# Addendum

No. ONE Date: 10.12.20

**Re-Roofing Various Buildings at  
Geneva County High School for the  
Geneva County Board of Education  
Geneva, Alabama**

**MCKEE PROJECT NO. 2020.220  
ALABAMA DIVISION OF CONSTRUCTION MANAGEMENT NO. 2020514**

SHEET TITLE : ROOF PLAN 'F', 'G' and 'H'; SINGLE PLY (ALTERNATE)  
 MCKEE JOB # : 2020-220  
 DRAWN BY : ks  
 DATE : 9-8-2020  
 REVISED DATE : ① 10-12-2020  
 REVISED DATE :  
 REVISED DATE :  
 SHEET NO. : **R1.3**

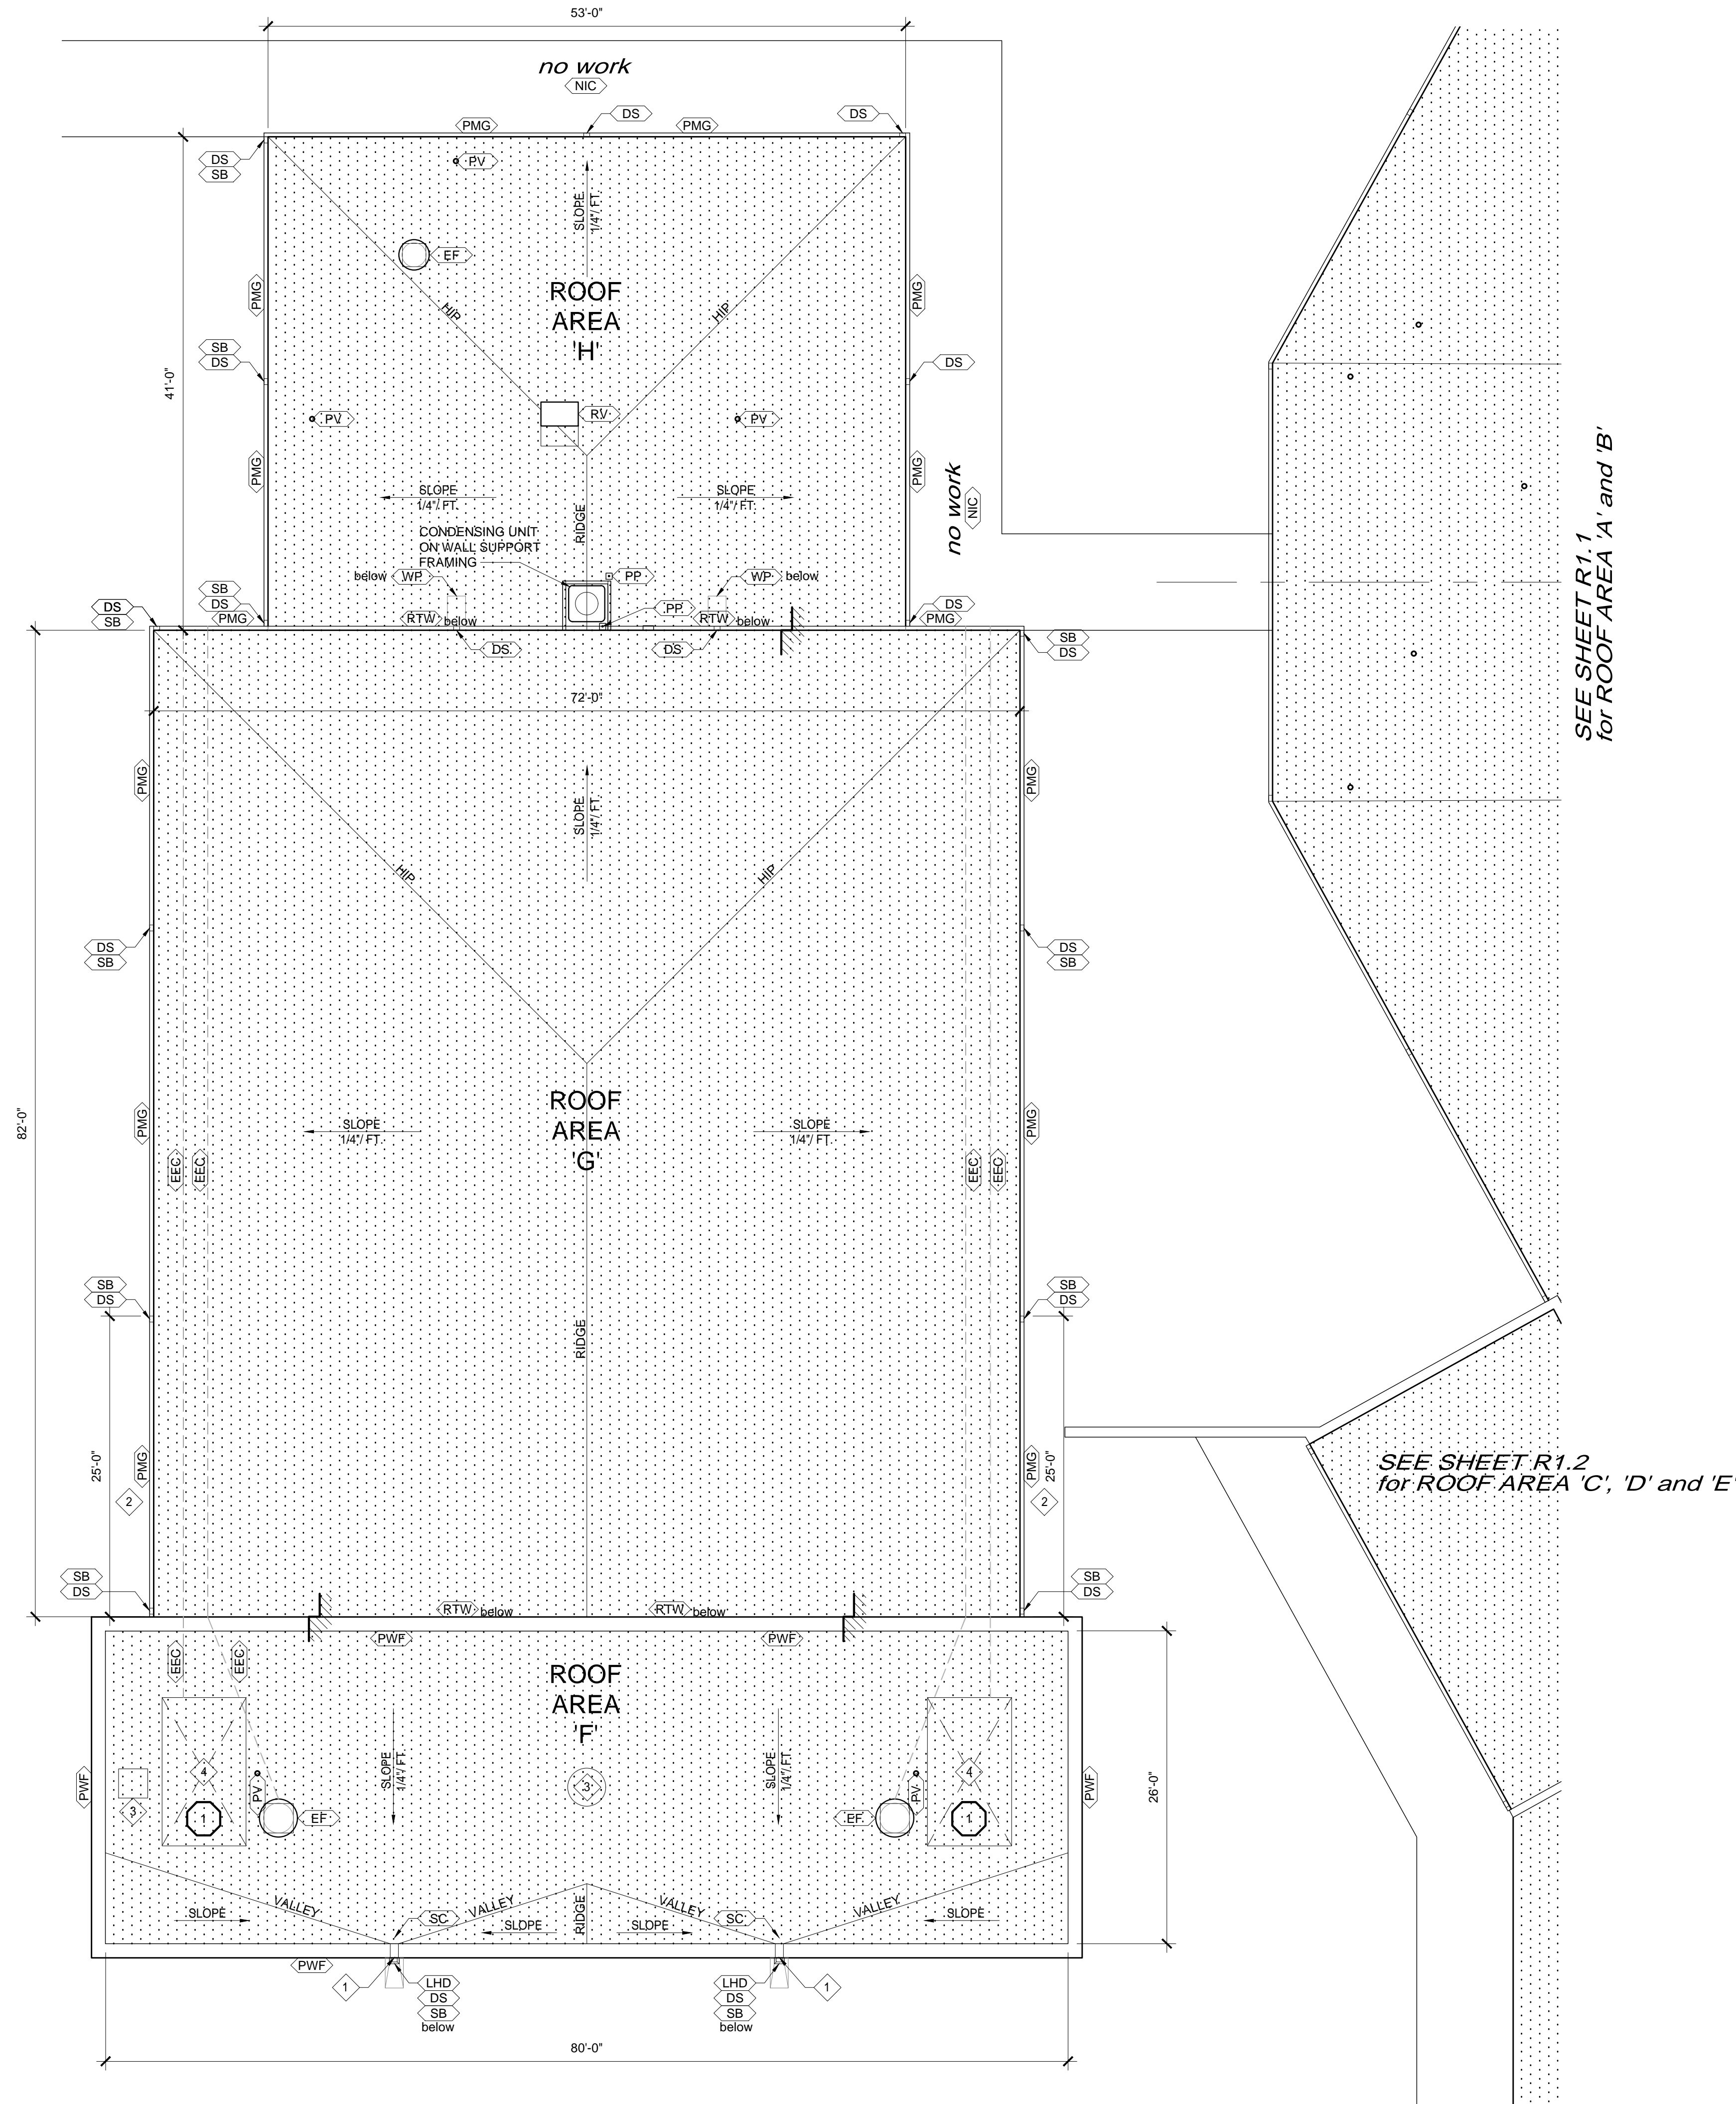
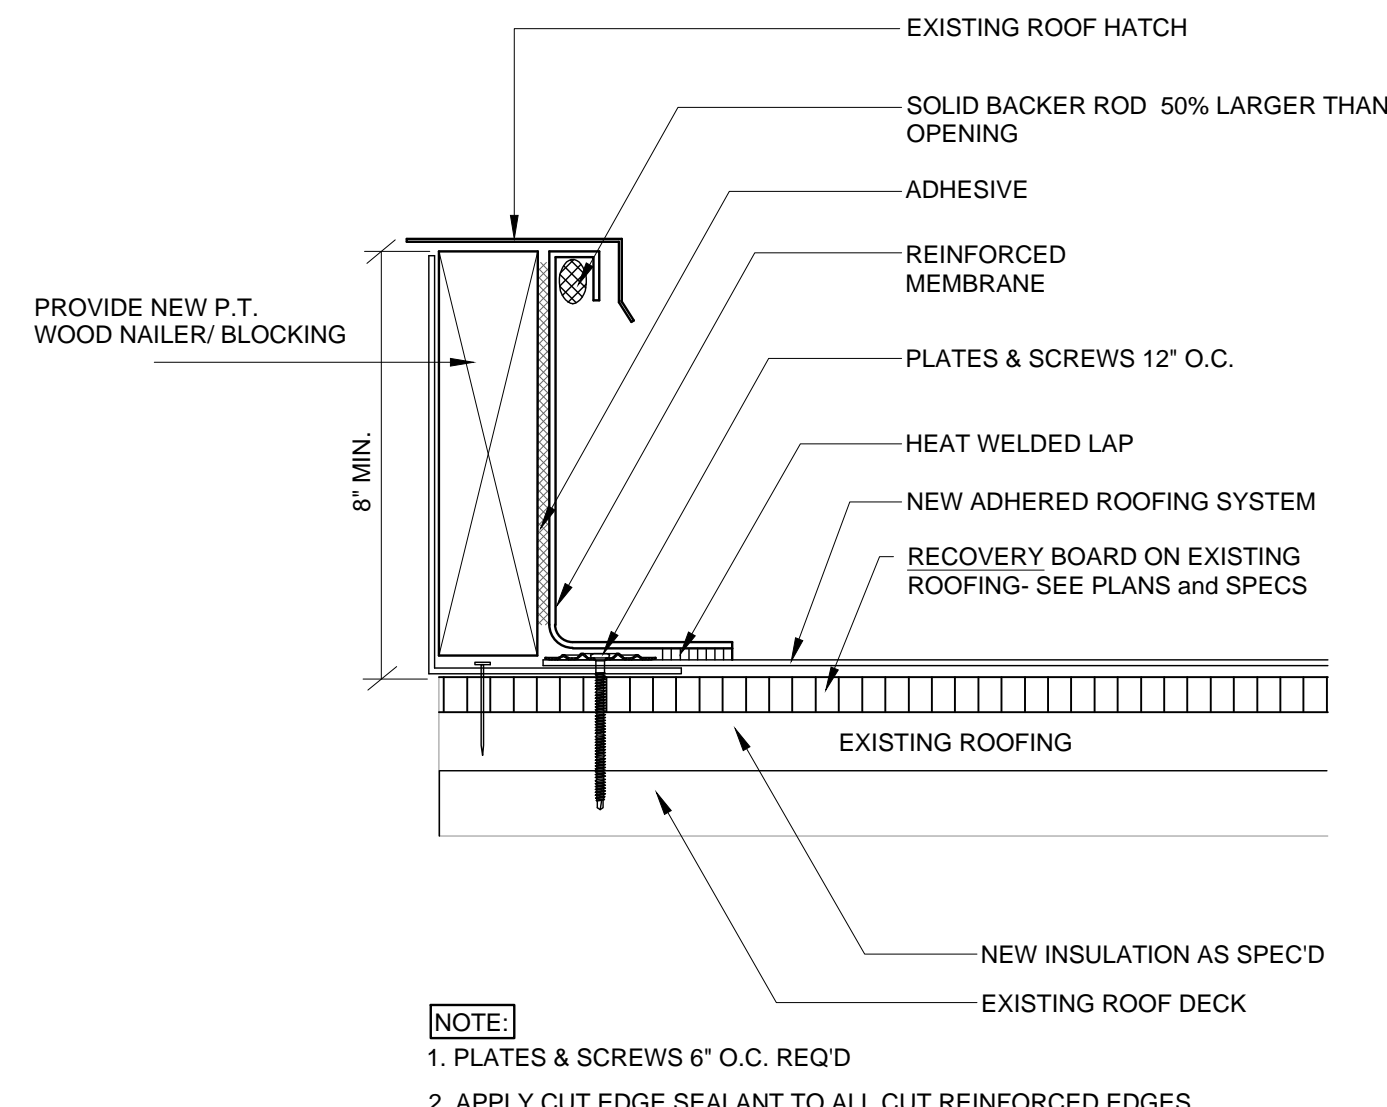
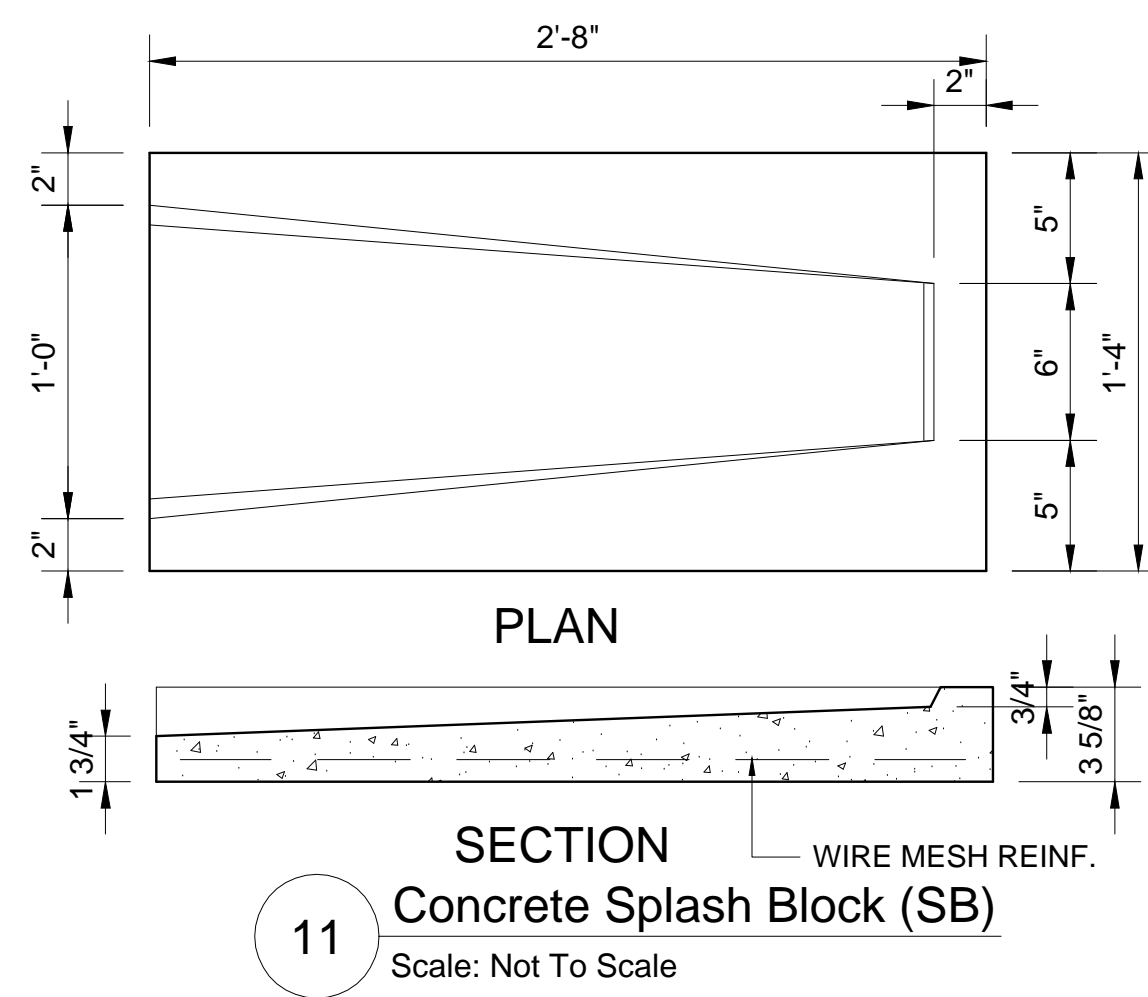
- A. See the attached Revised Drawings as follows:
1. Sheet **R1.3** and **R2.1**, **all Revised 10.12.20**, herein.

- A. See the following clarifications as follows:
1. All rock ballast being removed are to be turned over & stock-piled on site as directed by the Owner.
  2. Existing roof mounted HVAC units on the auditorium (rear) are to be removed and disposed. Verify with owner prior to removal. Infill openings with new decking to match existing and provide new roof system to achieve a uniform slope. See sheet R1.3.
  3. Any Existing louvers encountered are to remain functional.
